**TOWN OF BAY HARBOR ISLANDS
PLANNING AND ZONING BOARD**

March 3, 2015

FINAL AGENDA

MMPA recommends the Planning and Zoning Board review the contents of this staff report, the submitted site plan and architectural plans (dated 02/17/15) and if felt to be acceptable, **APPROVE** the plans as submitted or with modifications as deemed appropriate and/or with conditions, to allow for the construction of a new single-family house at 1260 95th Street.

EXISTING NORTH ELEVATION

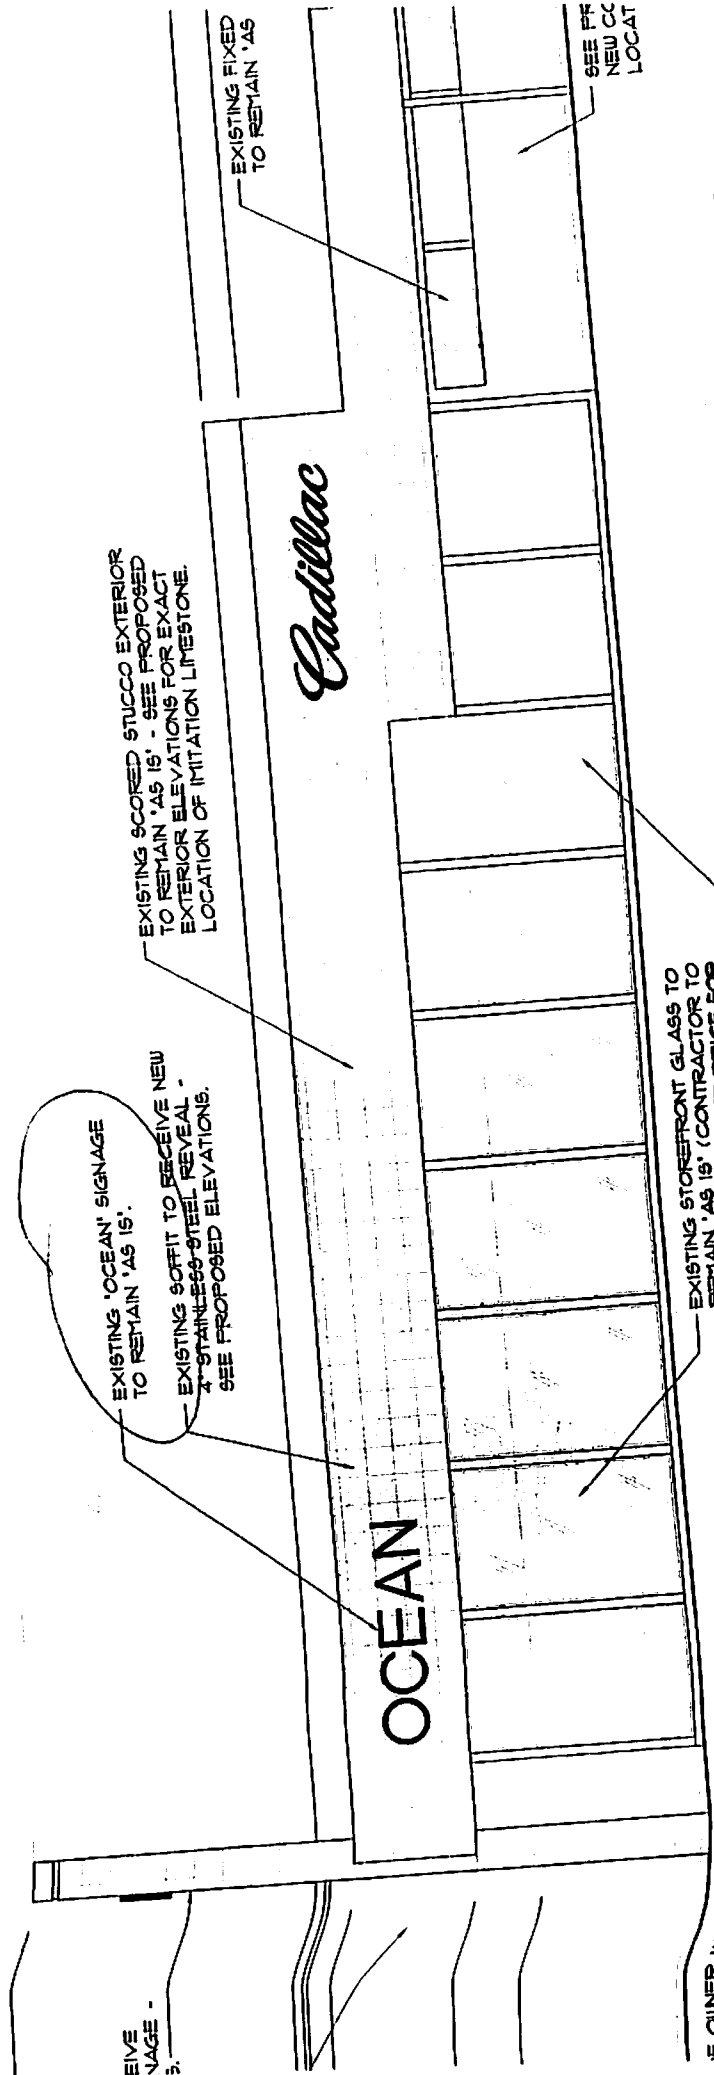
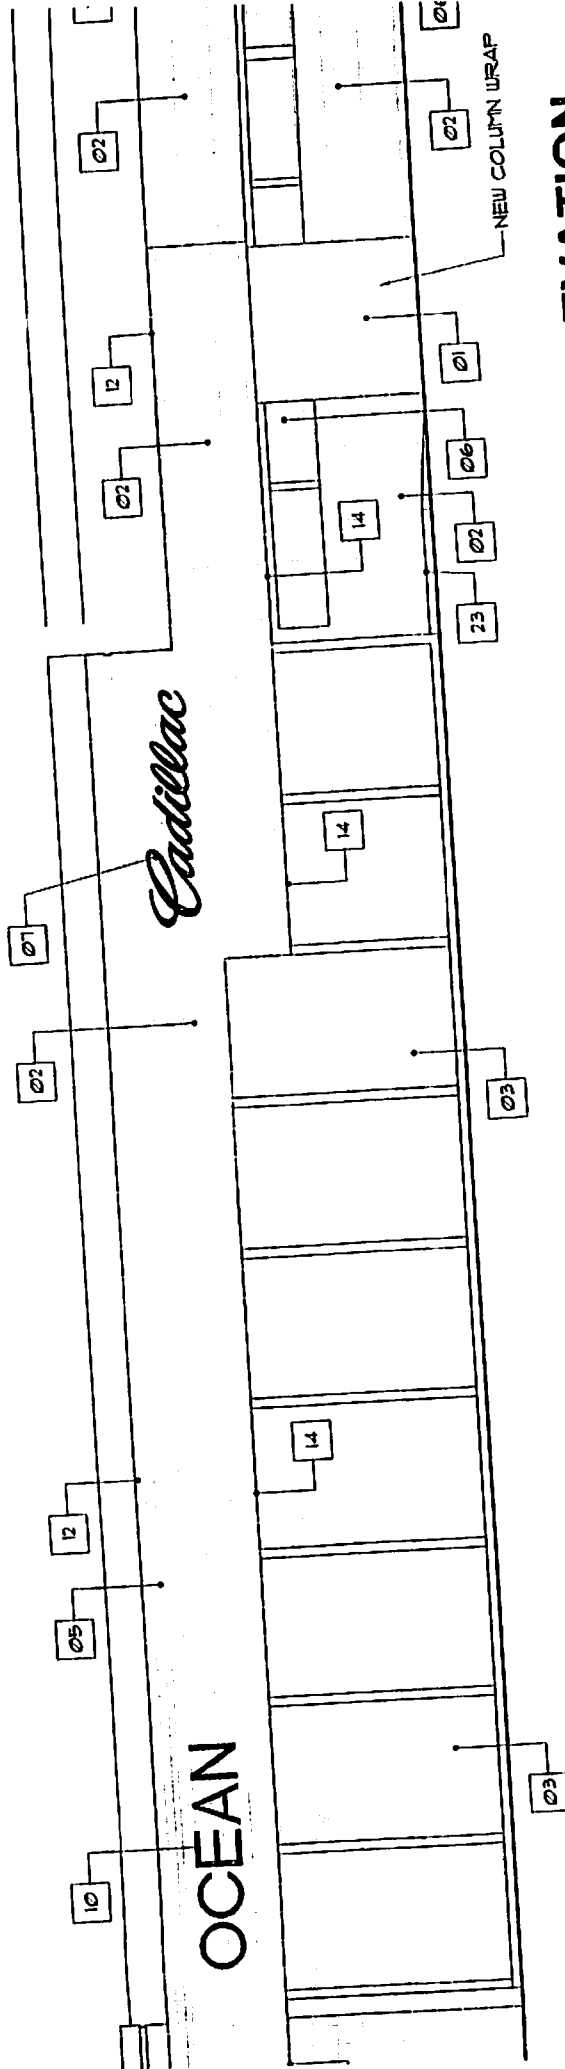
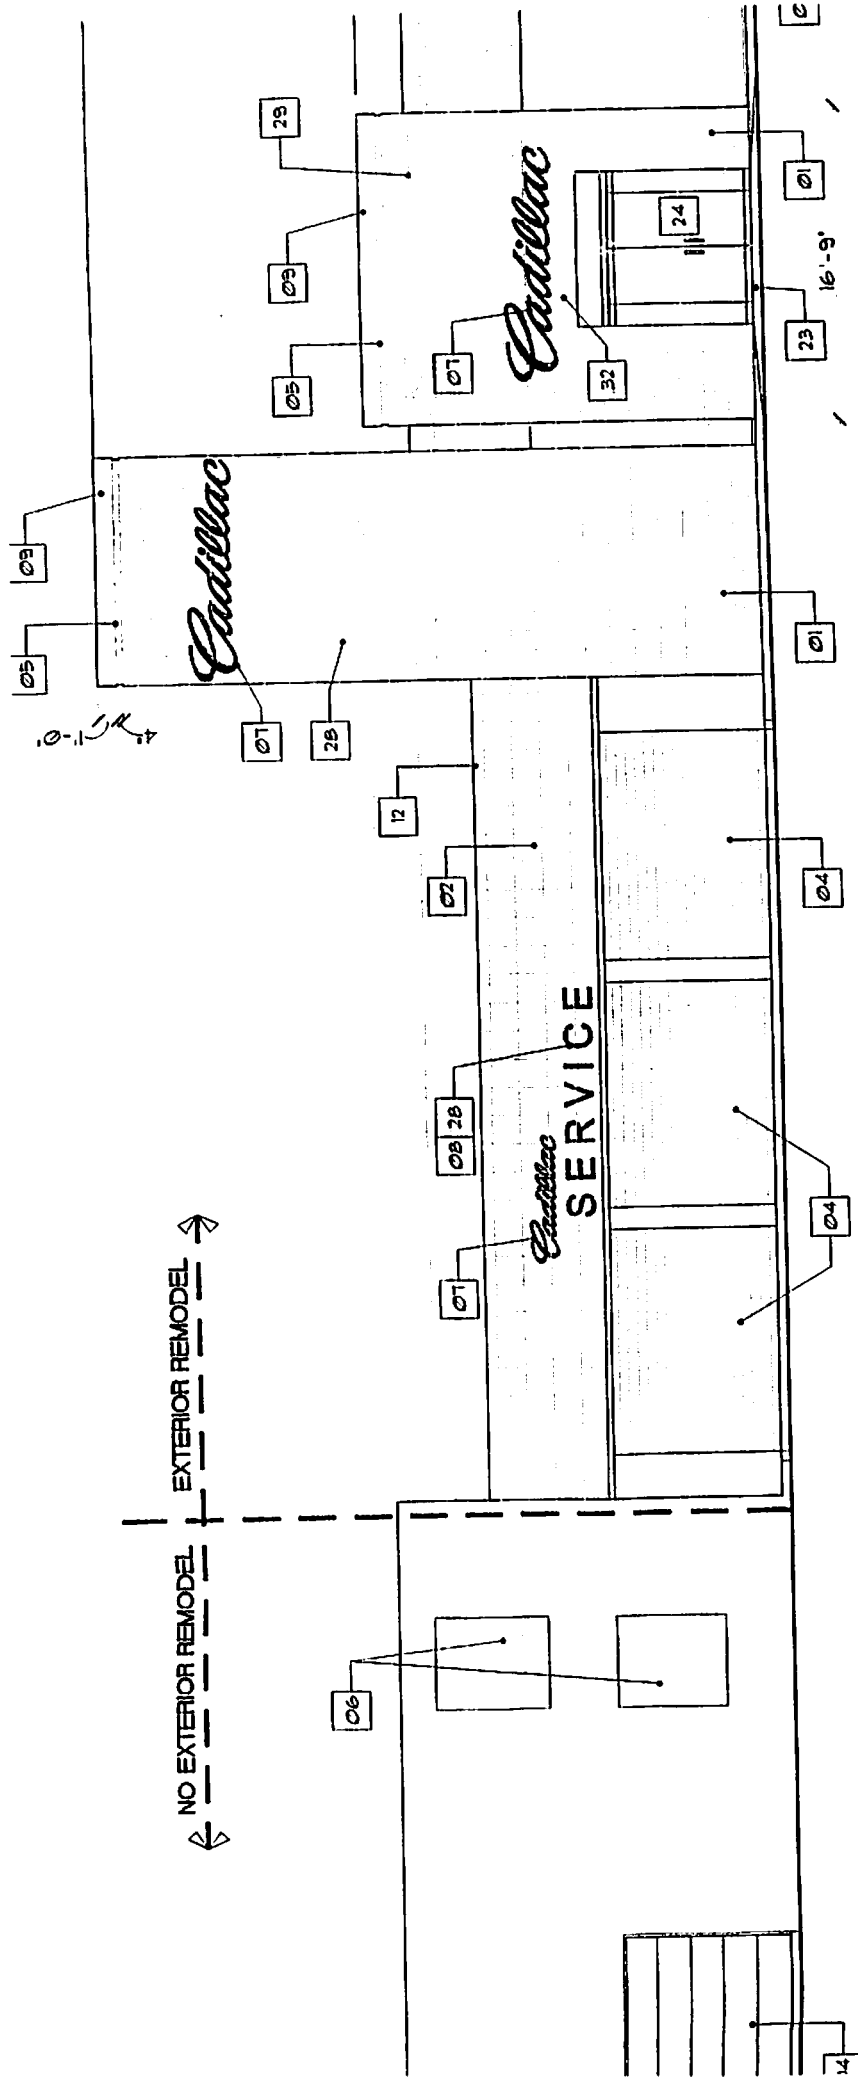
MMPA has researched the previous Town approval from 2012 and provided copies of applicable sheet details for information. MMPA has also created a table to illustrate the Code requirements and request. Clearly this land use is unique – car dealers are not even listed as a permitted use in the Town – so the use is considered “grandfathered”. The original facility was apparently built in 1951 according to Town records. The ownership of the car dealership changed recently. So the people that planned for / received the 2012 Town approval have changed and some of the design details desired by the new owners are requested to be changed. While business signage is important, almost everyone for 64 years knows where Ocean Cadillac is located. Excessive signage is unnecessary as Kane Concourse is not a main busy thoroughway like most locations where car dealerships are located. The requested sign locations and quantities are not excessive in our opinion, as they have been there for decades. The building façade where the new “Cadillac” sign is proposed was to be enlarged per the 2012 approved plans – it was not enlarged in the renovations. That proposed sign does not appear excessive in size. The tower logo size was discussed by the PZB at a recent meeting as it was felt to be too large for the façade it would be attached to. The 2012 approved plans included a “Cadillac” name sign on the tower – the new request is for a rectangular logo. Both designs showed the logo / sign extending almost to the outer edges of the tower, rather than centered with borders like the existing round logo. This is a matter of acceptable design proportions and appearance. Many cities require a “border” for signs from the edge of the surface it is attached to ranging from 10%-25% of the façade dimensions – the Town does not have such provisions. The tower is about 12 feet in width and the existing circular logo is placed with 2+/- foot borders (17%). These thoughts are provided for the PZ Board's information

1.5 square feet of sign per linear foot of store front; Maximum of 30 square feet (1.5 x 84 foot store front = 126 square feet)	Ocean: 22.5 square feet Cadillac: 19.5 square feet Total: 42 square feet
Maximum of 18" letter height, minimum of 12"	Ocean: 27" uniform letters Cadillac: 18" base letters, up to 36" for the capital C
Maximum sign length: 60% street frontage (84 foot store front x .60 = 50.4 feet)	Ocean: 10 feet Cadillac: 13 feet Total: 23 feet
ALONG EAST BAY HARBOR DRIVE SECONDARY STREET FRONT SIGNAGE: 50% OF ABOVE CRITERIA PERMITTED ("CADILLAC" LETTER AND LOGO SIGNS PROPOSED)	
One primary sign per store front (second allowed for corner lots @ 50% criteria)	2 signs proposed – "Cadillac" letter and logo (Service sign is for directory purposes)
Maximum of 15 square feet (50% of above criteria)	Cadillac: 16 square feet Logo: 26.4 square feet Total: 42.4 square feet
Maximum of 9" letter height, minimum of 6" (50% of above criteria)	Cadillac: 16" base letters, up to 33" for the capital "C" Logo: 38"

Maximum sign length: 30% street frontage (50% of above criteria) (84 foot store front x .30 = 25.2 feet)	Cadillac: 12 feet Logo: 8.3 feet Total: 20.3'

84' EAST ELEVATION

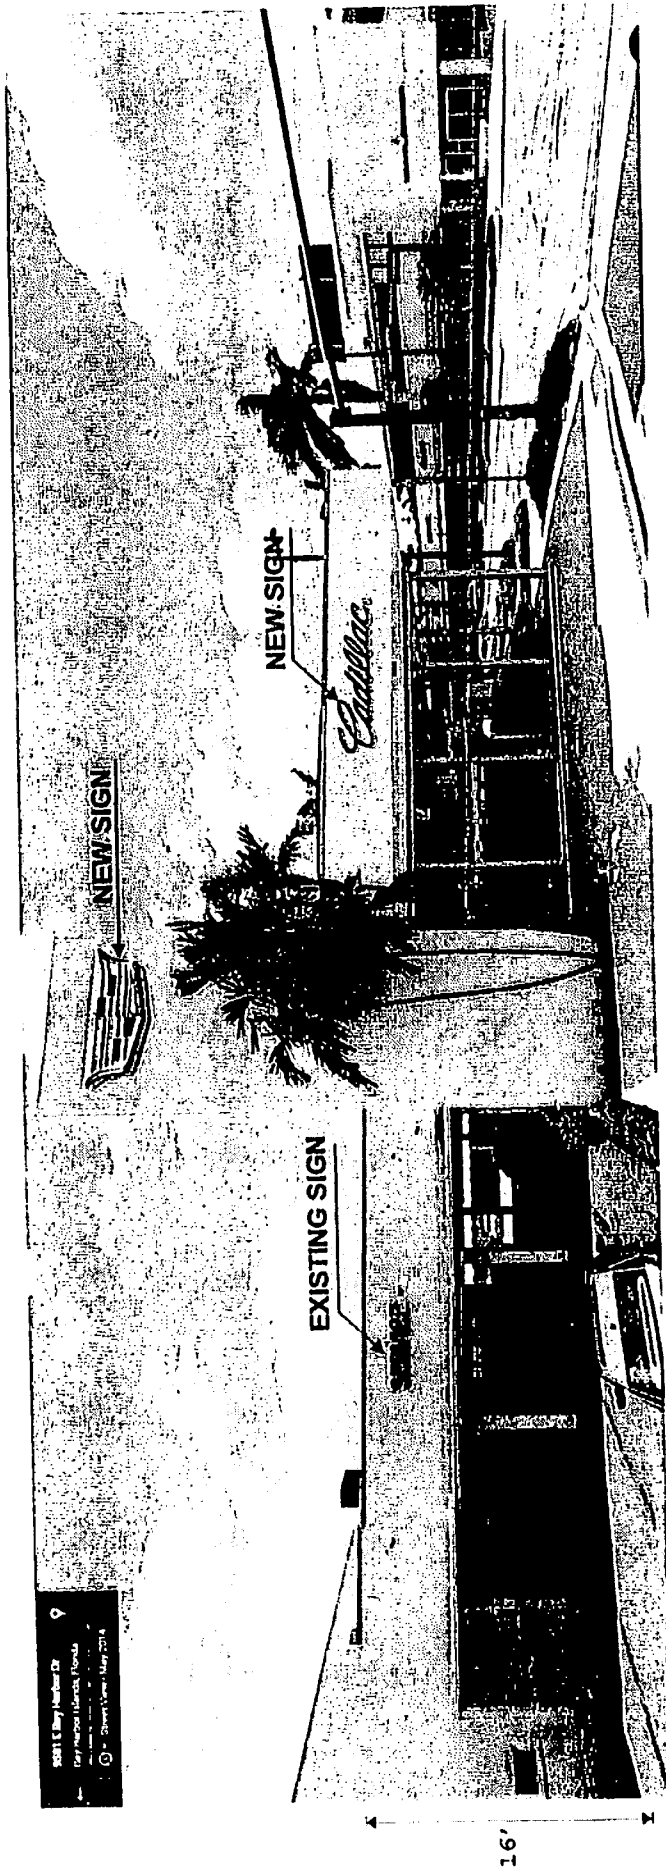
The large logo on the tower and the "Cadillac" sign facing East Bay Harbor Drive will need Planning and Zoning approval as they are larger than the code permits.

The applicant is requesting Planning and Zoning Board approval for the two secondary business signs on East Bay Harbor Drive that vary from Sec. 17-20(a)(2) to allow for two (2) signs and lettering / logo sizes larger than the maximum permitted.
